**DREAMY DRAW WASH WEST AT ACDC
LOMR PACKAGE FOR ZONE AE FLOODPLAIN WITHOUT
FLOODWAY**

FCD Contract No. 1999C048 - Assignment # 3

TECHNICAL DATA NOTEBOOK

IN REPLY REFER TO:
Case No.: 01-09-285P

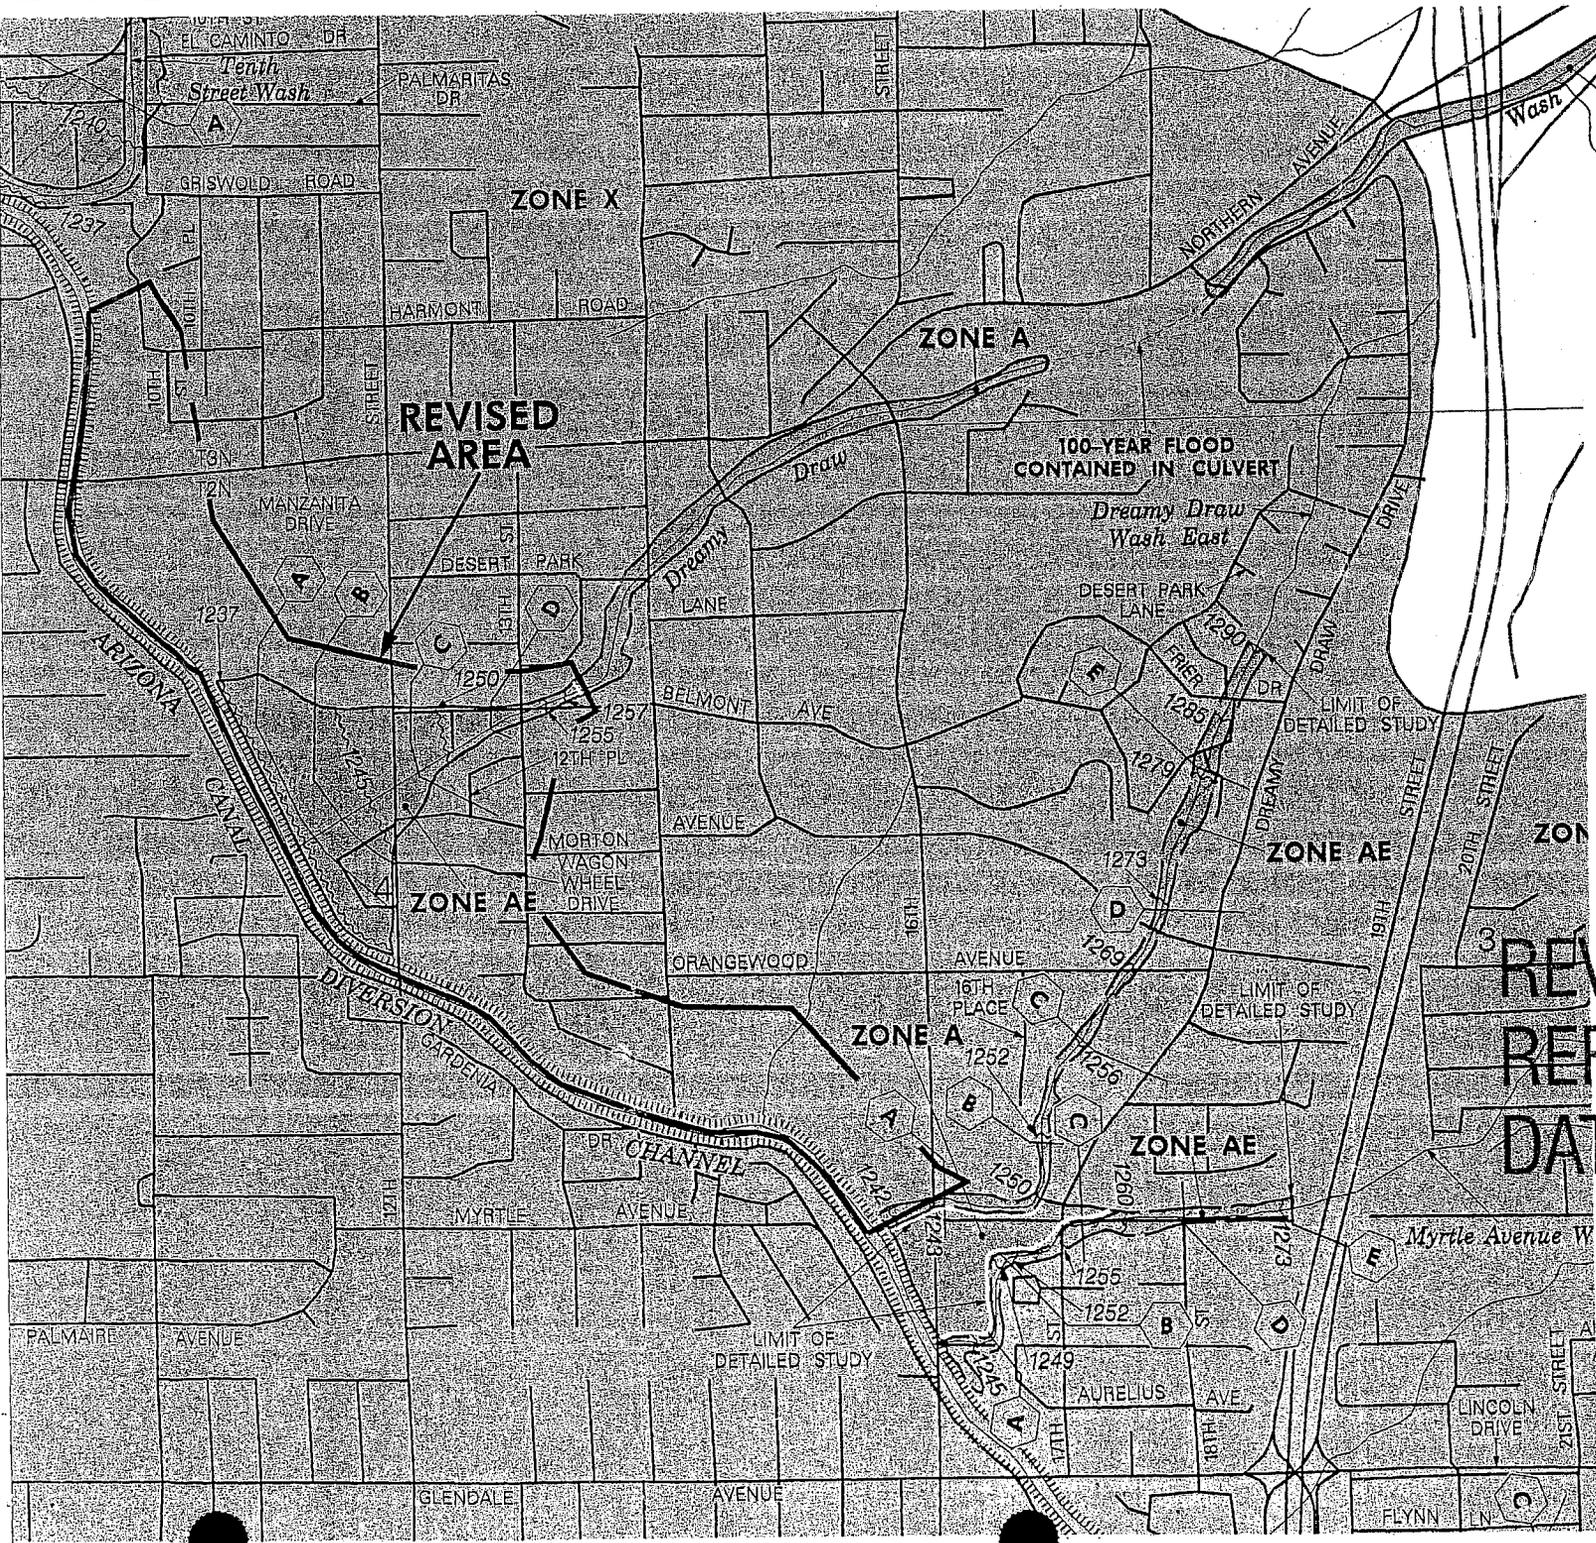
We have completed our review of the submitted data and the flood data shown on the effective FIRM. We have revised the FIRM and FIS report to modify the floodplain boundary delineations and zone designations of the base flood along Dreamy Draw Wash West. As a result of the modifications, Base Flood Elevations (BFEs) were established, and the width of the SFHA decreased along the northeast side of the ACDC from the Myrtle Avenue alignment to the Griswold Road alignment and along Dreamy Draw Wash West from the confluence with the ACDC to approximately 300 feet northeast of the intersection of 13th Street and Belmont Avenue. The SFHA previously designated Zone A, with no BFEs determined, was redesignated Zone AE, with BFEs determined. The modifications are shown on the enclosed annotated copy of FIRM Panel 04013C1670 F and affected portions of the Summary of Discharges Table. In addition, Profile Panel 1165P was added to the FIS report. This LOMR hereby revises the above-referenced panel of the effective FIRM and the affected portions of the FIS report, both dated July 19, 2001.

The following table is a partial listing of existing and modified BFEs:

INDEX MAP

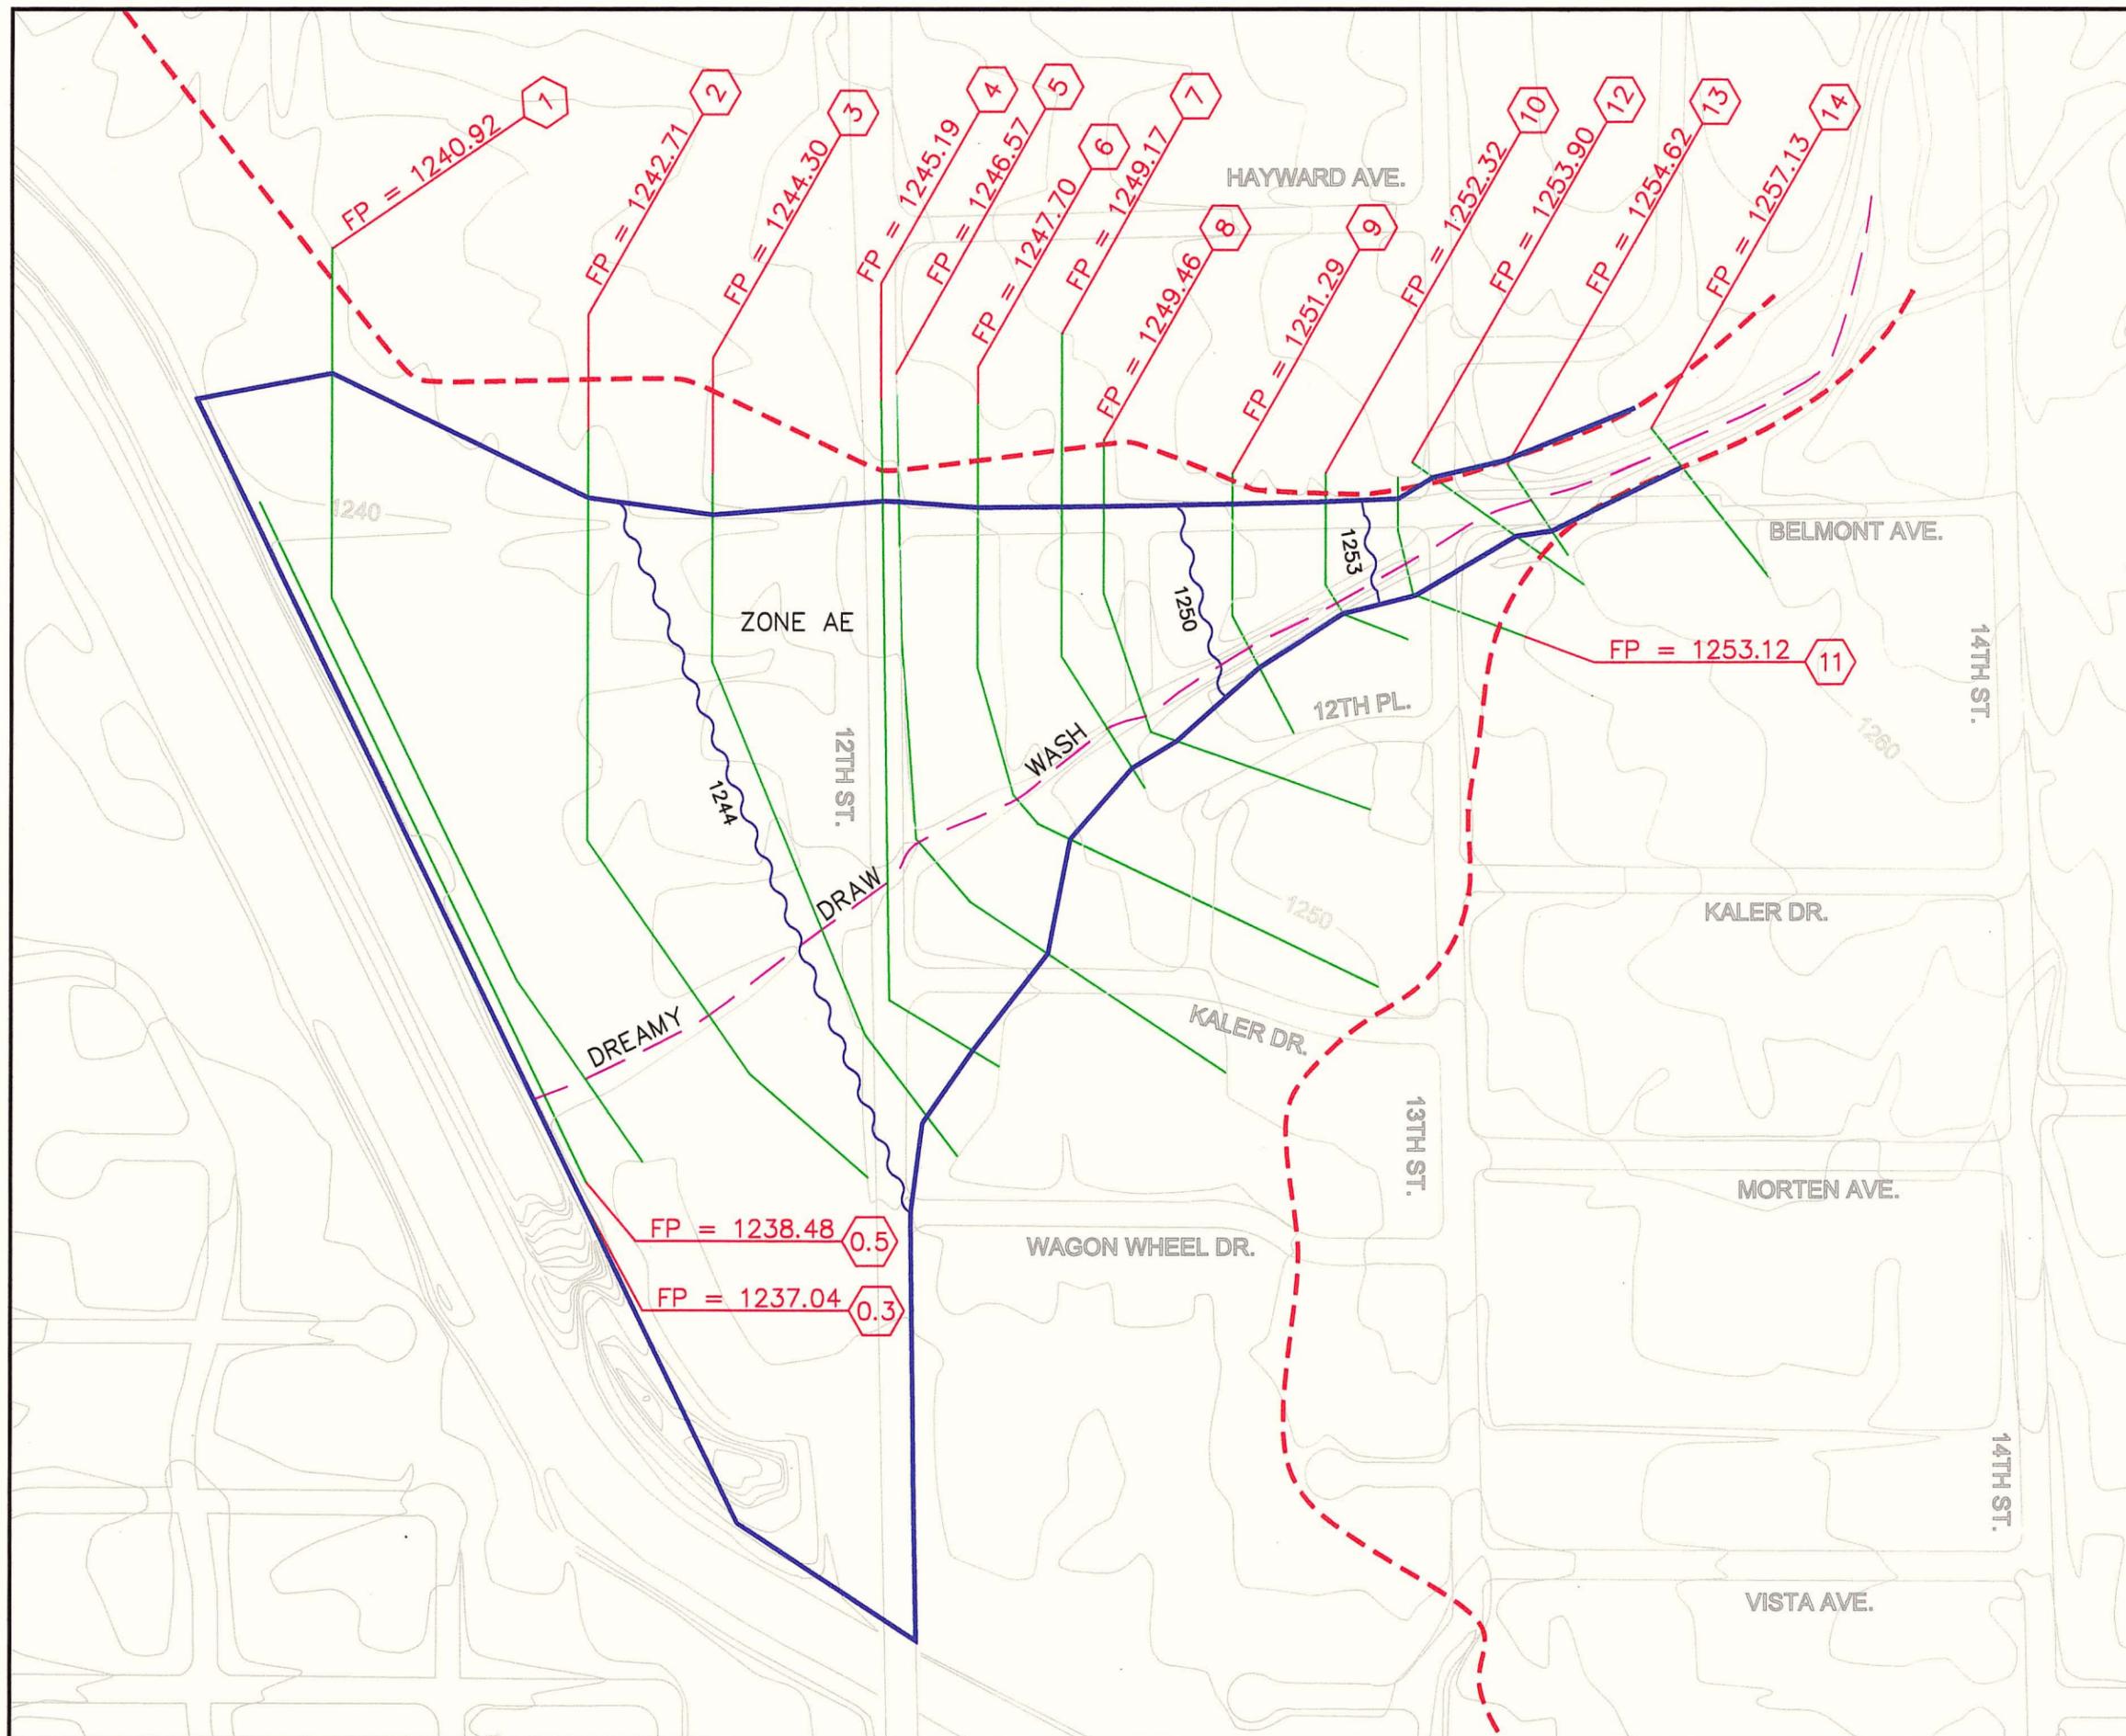
Comment #1 – *Graphical tie-in to effective floodplain boundary*

Comment #2 – *Discrepancies between topography and BFE at several cross sections*

Comment #3 – *Top width discrepancies between HEC-RAS model and work map*

1. The proposed floodplain boundary delineations do not graphically tie into the effective floodplain boundary delineations at the upstream end of the revised reach. Please submit a topographic work map that includes a graphical tie-in between the revised and effective floodplain boundary delineations.

3. The base floodplain topwidths shown on the revised proposed conditions hydraulic analysis from Cross Section 0.5 to Cross Section 7 do not match the corresponding approximate base floodplain topwidths shown on the above-referenced topographic work map. Please provide an explanation for these discrepancies, or make the appropriate changes.

The discrepancies between topographical and base flood elevation lines are due to the adjustment of model output prior to mapping. See section 5.9.1 – Hydraulic Analysis Results – in the existing TDN for an explanation of these adjustments. As a result of these adjustments, the mapped extent of the floodplain does not agree numerically with the base flood elevations calculated by the hydraulic model. Adjusting the results in this manner does, however, result in a more reasonable and more conservative mapping of the floodplain.

As with Comment #2, the discrepancies between model top widths and those plotted on the work map result from the adjustments described in section 5.9.1 of the TDN text. For cross sections 0.5 through 3, the left edge of the floodplain was drawn south along the outside edge of 12th Street. For cross sections 4 through 7 (actually 8, as well), the floodplain was mapped along the north edge of Belmont Avenue for reasons described in Comment #2. Due to these manipulations of the floodplain
